**Re: Defect Information Report - Supplemental Report No. 3
08V-356, FL-534, TBB MVP-ER Alternator Cable Routing**

Subject: RECALL 08V-356 – Power Cable Routing

RECALL #08V-356
INSTRUCTION SHEET #TBB 85490100

SUBJECT: POWER CABLE ROUTING

Figure 2

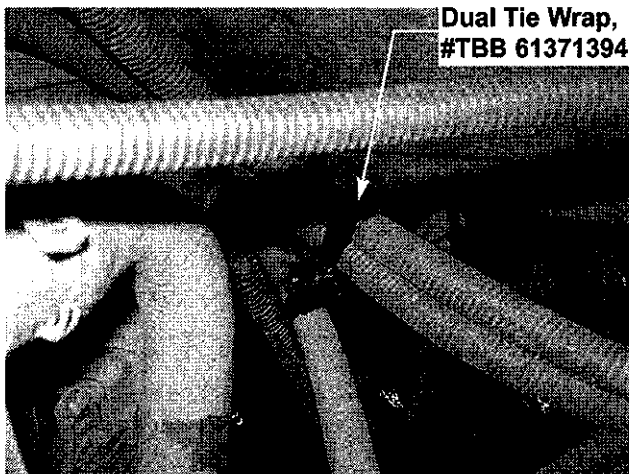
8. If no damaged to the copper strands is found, install Dual Tie Wrap, #TBB 61371394 to secure cable and fuel line. **MAKE SURE THEY DO NOT TOUCH. Figure 2**

Figure 3

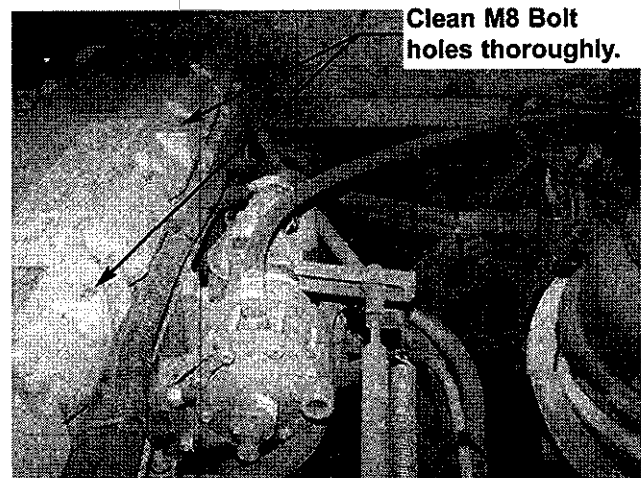
9. Locate and clean the two M8 bolt holes on the top right side of the valve cover as shown in **Figure 3**. Using brake cleaner and a screwdriver, clean the bolt holes thoroughly of all debris before proceeding.

10. Install the two Dual Tie Wraps, #TBB 61371394 and the Stand Off Bracket, #TBB 62360291 with 1/4 Hex Bolt, #TBB 61370805, two Flatwashers, #TBB 61370348, and Locknuts, #TBB 61370078 over both 1ga. wires at area of bolt holes on the top right valve cover and affix clamps to the valve cover using two M8 Bolts, #TBB 61370883 and Lockwashers, #TBB 61370263. **Figures 4, 5, & 6.**
11. If needed for rigidity, install Dual Tie Wraps, #TBB 61371394 at any point where the wires span is greater than 6".
12. Inspect fuel line for damage.
13. Replace fuel line if insulation is worn to the point of exposing the braided metal mesh. Refer to BOM for part number.
14. Reinstall battery cables.
